Westinghouse
Electric Corporation

NTD-NRC-94-4337
DCP/NRC0242
Docket No.: STN-52-003

SUBJECT: WESTINGHOUSE RESPONSES TO NRC REQUESTS FOR ADDITIONAL
INFORMATION ON THE AP600

NTD-NRC-94-4337
ATTACHMENT A
AP600 RAI RESPONSES
SUBMITTED NOVEMBER 11, 1994

Figure 231.26-10
2D SASSI Analysis, E-W Direction
Parabolic Soil Profile Evaluation

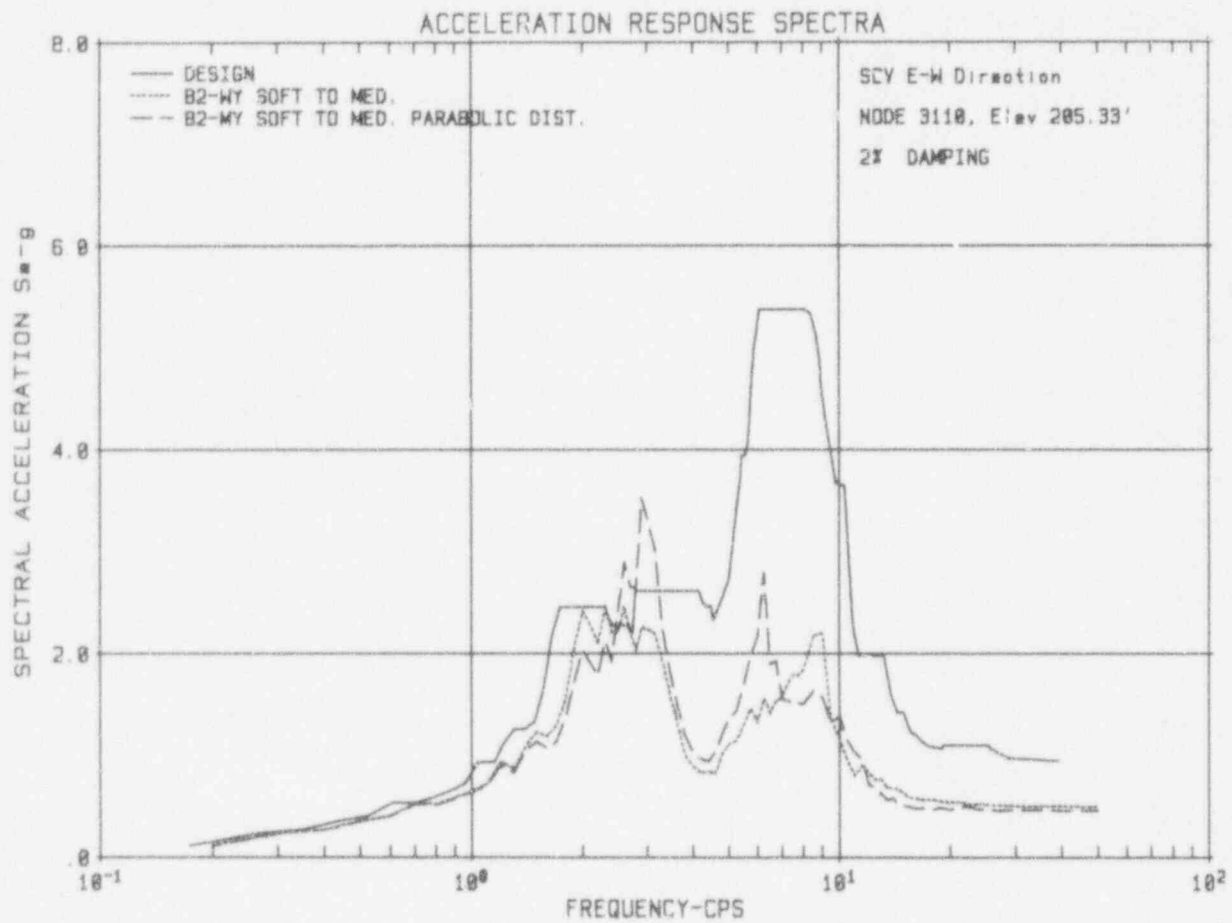
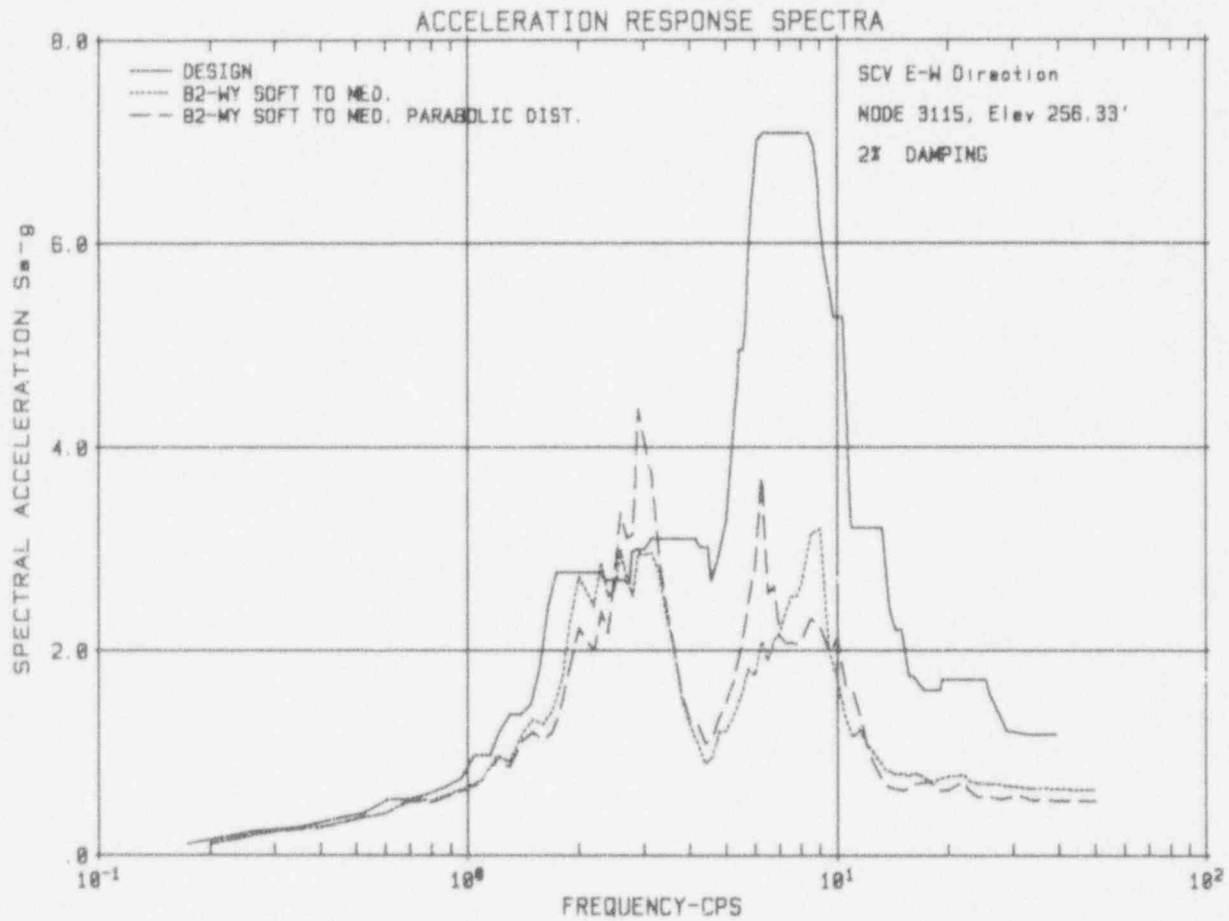
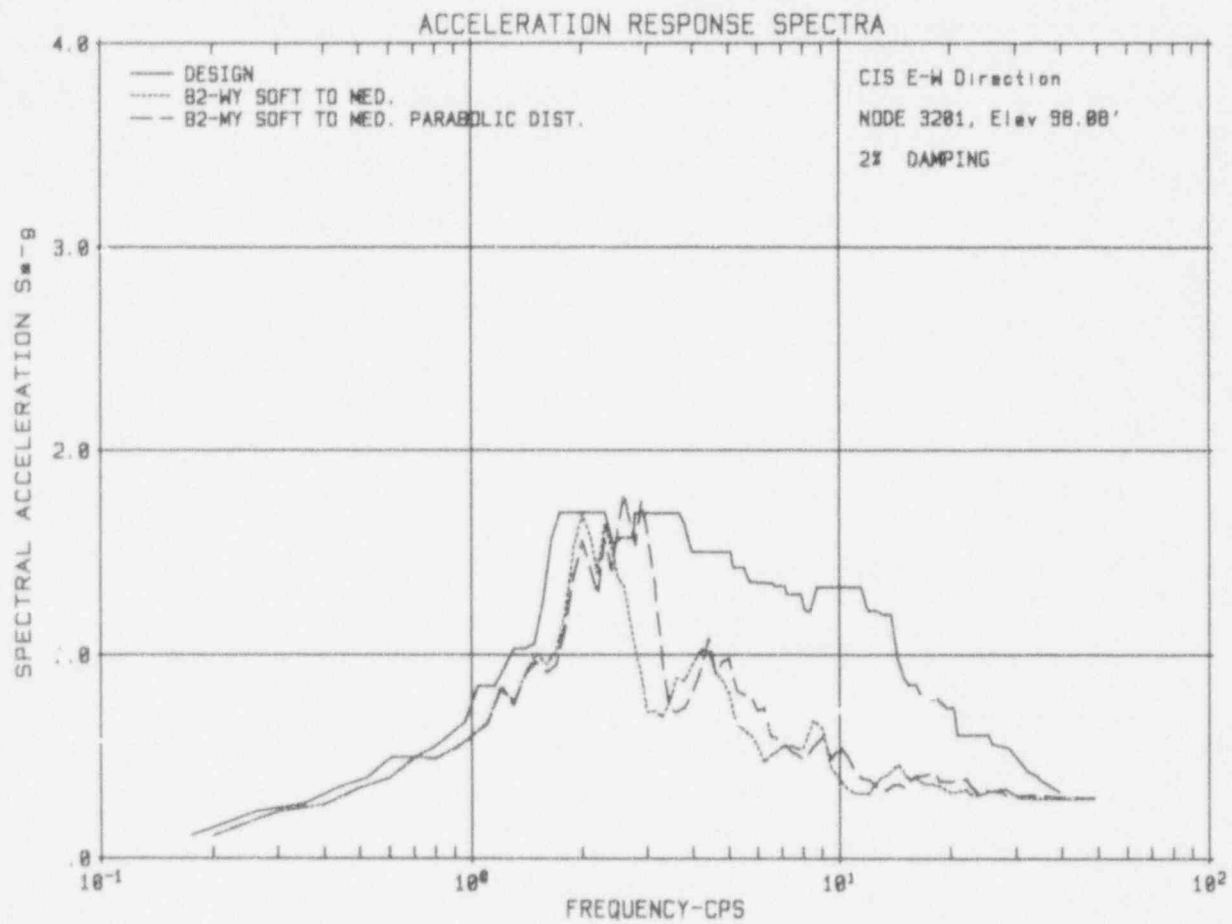
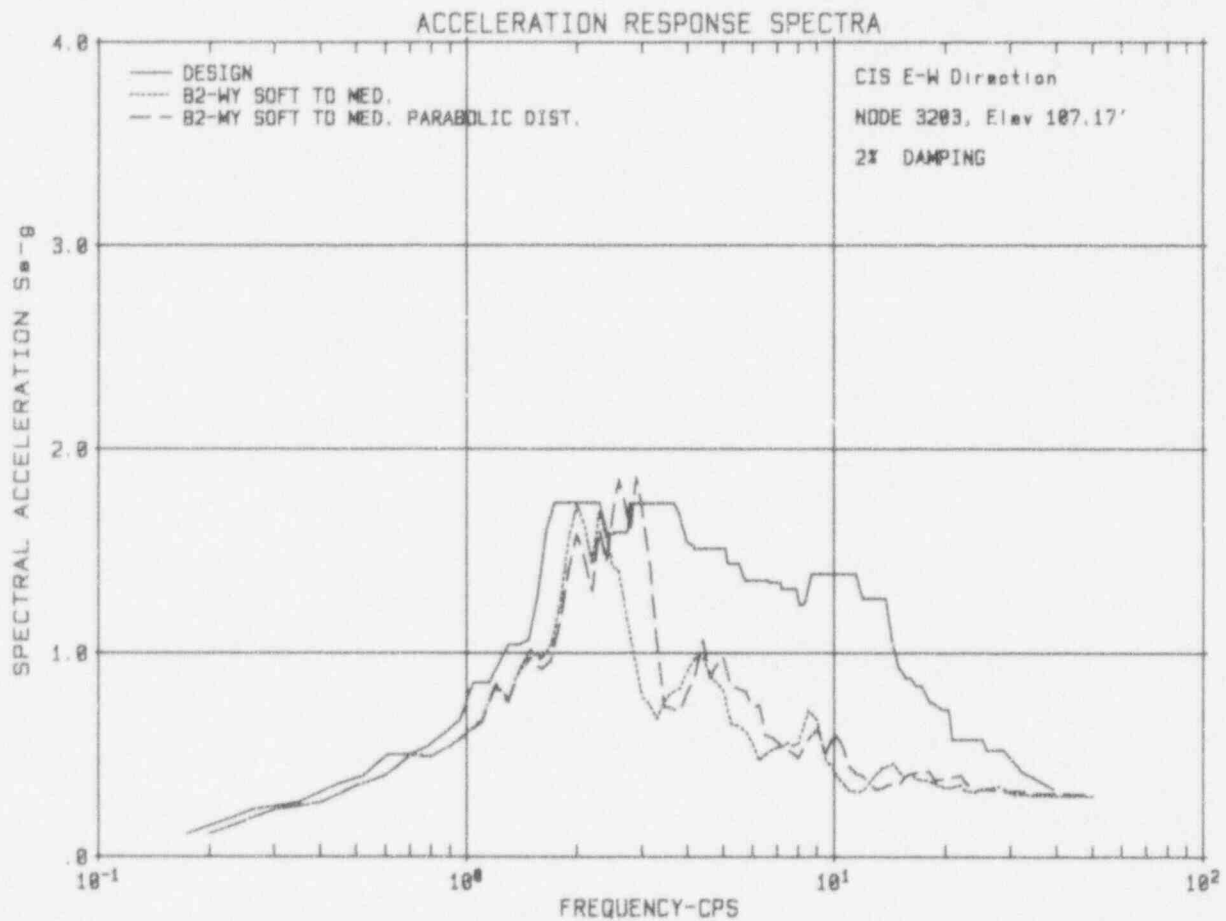
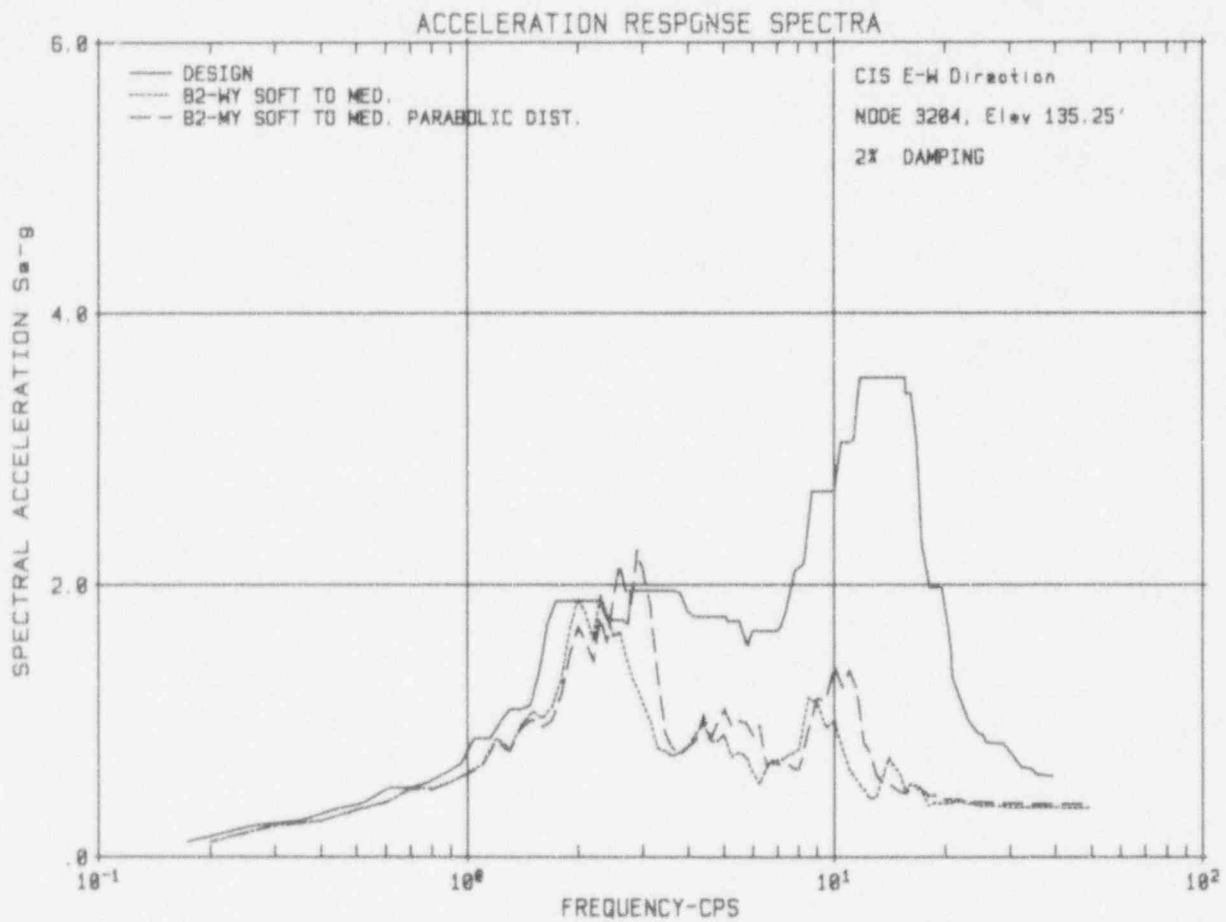
The properties of the soft-to-medium soil column given in Table 2A-6 of the SSAR show the shear wave velocity varying linearly from 1000 fps to 2400 fps. Typical variations at sandy soil sites are expected to be curvilinear, with most of the increase in soil stiffness occurring near the upper one-third part of the soil layer due to the nonlinear effects of depth of burial on stiffness. Because such variations may lead to significant differences in soil pressures over the depth of embedment of the NI, as well as changes in free-field ground motions at the foundation mat, provide a comparison of free-field motions at the foundation level obtained from SHAKE deconvolution analysis to indicate the sensitivity of response to this assumption.

The case of soft-to-medium soil with shear wave velocity of 1000 ft/sec at grade level increasing to 2400 ft/sec at 240 ft depth with parabolic distribution was analyzed. The maximum low-strain shear wave velocity and the strain-compatible velocity obtained from the SHAKE analysis, using the 1990 Idriss soil strain degradation curve described in the response to RAI 230.79, are shown in Figure 231.26-1. The response spectra of the free-field motion at 40 ft depth (foundation mat elevation) corresponding to parabolic and linear distribution of shear wave velocity case are compared in Figure 231.26-2. As shown in this figure, the response motion using parabolic velocity distribution shows small variations above and below that of the linear velocity distribution depending on the frequency. In order to study the effect of parabolic velocity distribution on the SSI responses, the SSI model in the EW direction was re-analyzed. In this case, the water table was considered at the grade level and the base rock was modeled at 120 ft depth. The strain-compatible properties obtained from the SHAKE analysis were used in the SSI analysis.

The SSI responses of this case are compared with the SSI responses of the same case with linear velocity distribution and enveloping design responses obtained from 3D analysis in Figures 231.26-3 through 231.26-13. These comparisons show that the responses with the parabolic distribution are generally similar to those with the linear distribution and enveloped by the design response spectra obtained for the 3D analyses. There is additional rocking of the nuclear island at a frequency of 3 Hertz which also results in higher peaks at this frequency for the containment internal structures (CIS) and the steel containment vessel (SCV). This increase at the 3 Hertz frequency is attributable to a combination of the following:

- The seismic input at the foundation level is higher for the parabolic distribution as shown in Figure 231.26-2.
- The stiffer soil properties for the parabolic distribution increase the rocking frequency for the nuclear island. This increased stiffness shifts the response closer to that of the soft rock. A comparison of the responses from the 3D design analyses are provided in SSAR Figures 3.7.2-25, 3.7.2-26 and 3.7.2-27.
- The H2 seismic input has significant frequency content at 3 Hertz. This is shown in SSAR Figure 3.7.1-7.

The design soil profile used for the 3D SASSI design analyses for the soft-to-medium soil case will be revised to the parabolic profile using the 1990 Idriss soil strain degradation curve. As shown in the figures, this will amplify the responses at about 3 Hertz and slightly reduce the responses at 2 Hertz. The revised analyses will be documented in the SSAR by July, 1995.
